CONSERVATION COMMISSION AGENDA

The Conservation Commission will hold this meeting as a virtual meeting on Thursday, October 8, 2020 at 7:00 pm. No in-person meeting will take place at City Hall.

1. 53 Wendell Rd – Minor Plan Change – DEP File #239-852

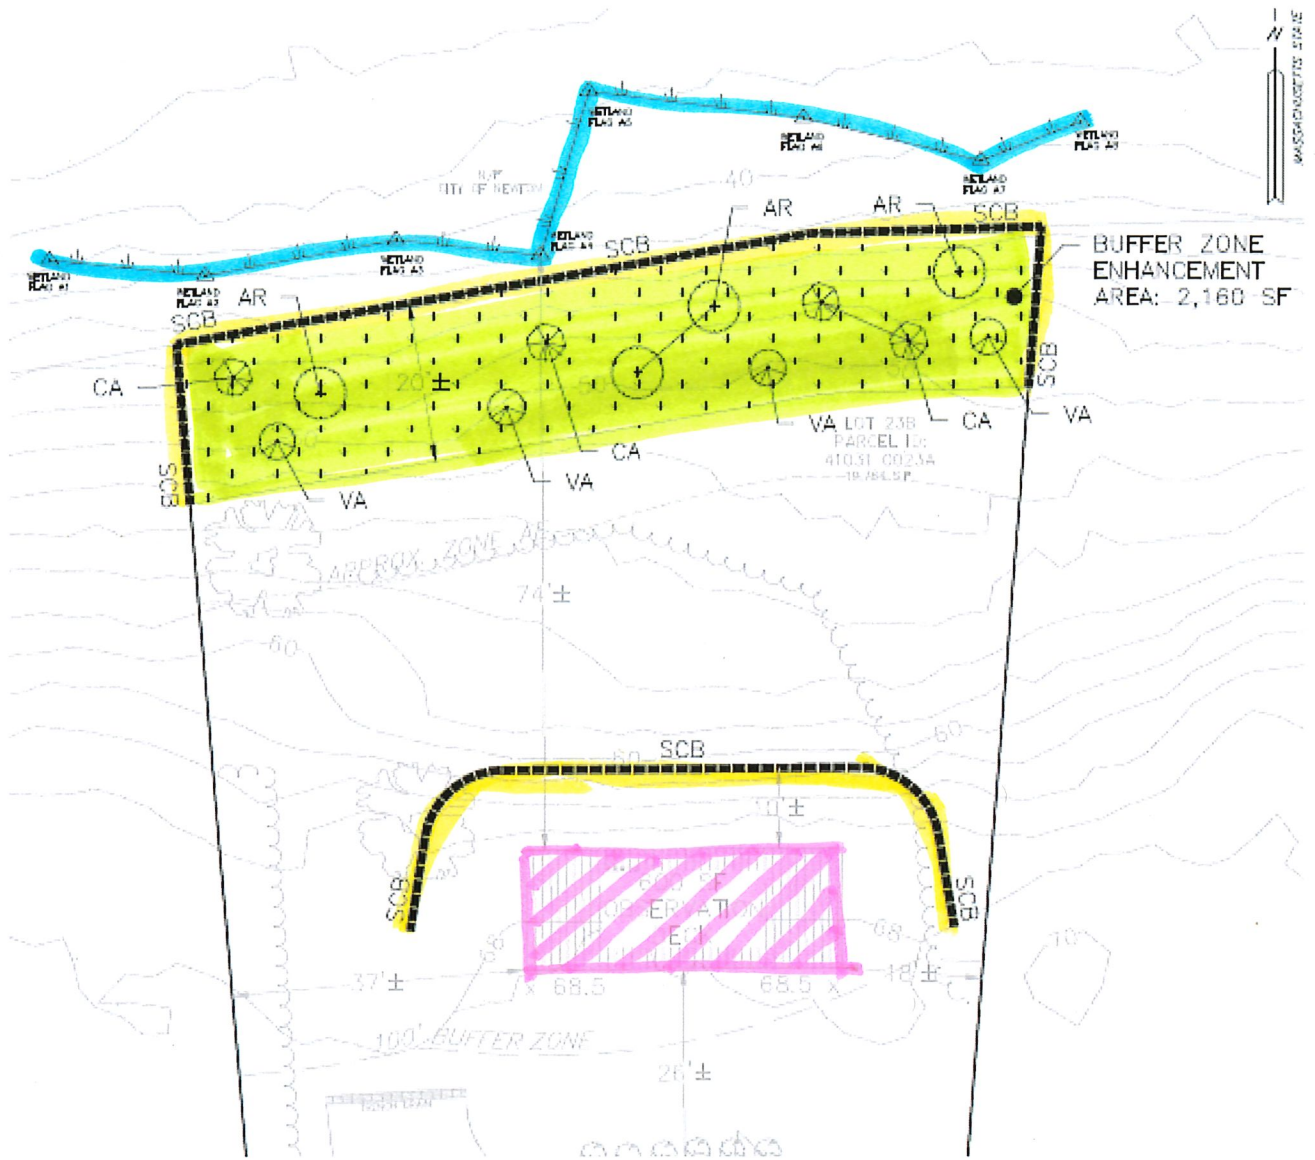
- Applicant has filed revised plans with the following changes.
 - The new garage is now entirely out of the 25' setback.
 - The new garage has been reduced in 20x24.5'.

- The new driveway has been reduced in width.
 - The two trees originally proposed to be removed are now proposed to remain, as they are now both outside the footprint of the proposed garage.

- Mitigation planting areas have been modified a bit.
 - Tree protection is proposed for both trees, but the large Norway maple has only "trunk protection", not drip-line protection due to proximity to the proposed work. The Norway maple's root zone should be protected (through conditions) either with plywood over roots for duration of construction or a limit of work snow fence line 5' from the driveway area and tree.

- Staff Recommendations: Vote to close the hearing and issue and Order of Conditions with the following special conditions.
 - Tree protection must be installed per the approved plans and plywood must remain over the root area for the duration of the construction period OR orange snow fence installed between the driveway area .

- If any trees within the wetland or buffer within the project area die within 2 years of the start of construction or have been demonstrably harmed by construction activities, they shall be replaced at a ratio of 2:1 with native canopy saplings (of roughly 2 caliper inches).

- The stormwater infiltration system must be installed as per the approved plans.

**33 Staniford
Aerial Representation
Proposed Deck
Newton, Mass.**

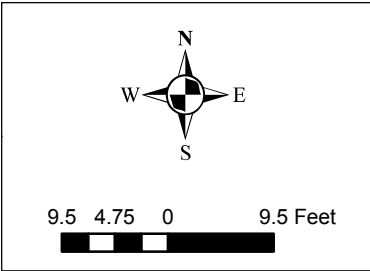
- The intention of improving the vegetation in this area is laudable.
 - Since the deck will project out over the scrub-vegetated slope (i.e., beyond the edge of lawn), it does not qualify for the “deck exemption.”

- The applicant should clarify what, if any, woody vegetation removal is proposed. Based on the staff site visit, it appears that two small trees may need to be removed for the construction of the deck.

- The applicant should clarify how the 10’ swath in front the deck and the area under the deck is due to treated, and how erosion will be precluded.
 - The applicant should clarify how Japanese knotweed will be addressed:

- Staff Recommendations: Once details are sorted out and approved, vote to close the hearing and issue and Order of Conditions with the following special conditions.

- The area (under and) in front of the observation deck must be appropriately stabilized and treated to prevent erosion.
 - The only vegetation removal approved by this Order is of Japanese knotweed and _____ (trees on the edge of the yard?).

- Invasive removal efforts must be initiated before or concurrent with the start of construction in order to ensure they are completed during the lifespan of this permit. Any changes in the invasive species treatment proposed must be reviewed and approved by the Conservation Office prior to initiation.

Bullough's Pond Seating Area
Soil Placement Plan 1"=5'-0"

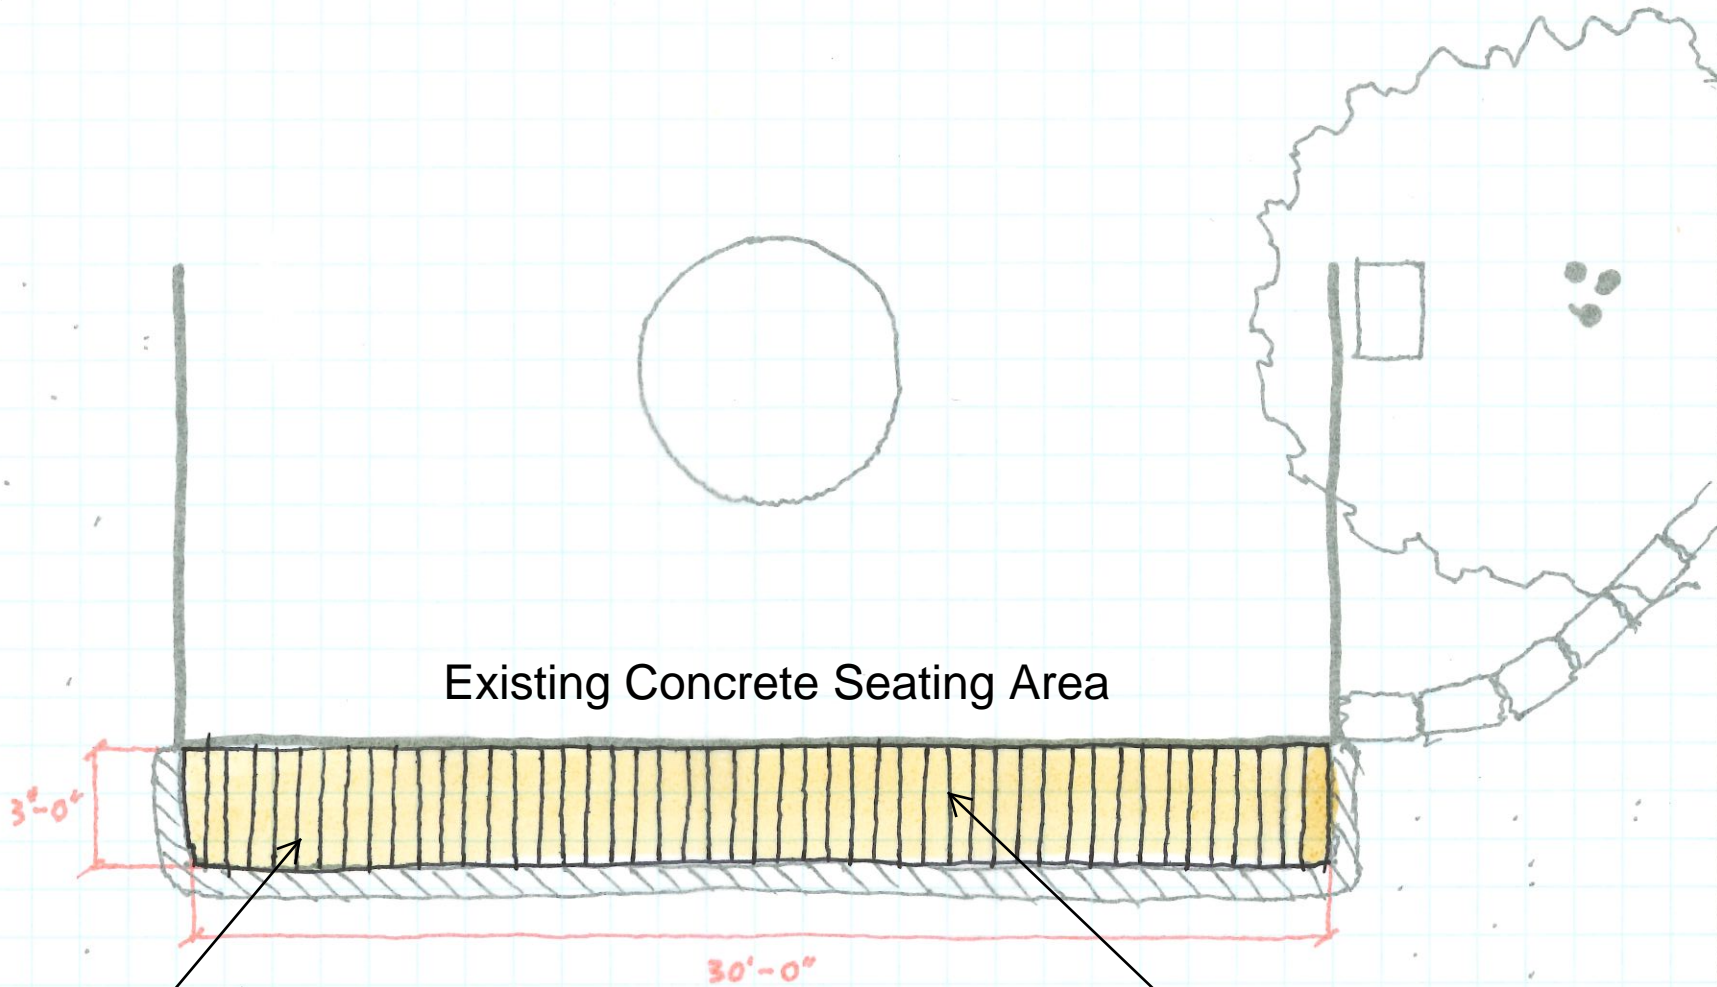
- On 9/13/19, Jennifer Steel made a site visit to check on the straw wattles that defined the area to be planted.
 - Sometime between September 2019 and September 2020, without PRC knowledge or approval and without ConCom knowledge or approval, the BPA had a retaining wall installed in front of the concrete slab. The area in front of the retaining wall remains unvegetated.

- PRC’s interests
 - PRC would support leaving the wall in place with after-the-fact permitting.
 - PRC staff do not want to have to take on after-the-fact permitting efforts. PRC would like BPA to work with the contractor they hired to develop and provide the ConCom with all appropriate application information including plans and details of the wall.

- When must materials be submitted?
 - What plans will the ConCom and PRC need to receive?
 - What, if any, further mitigation would the ConCom require?
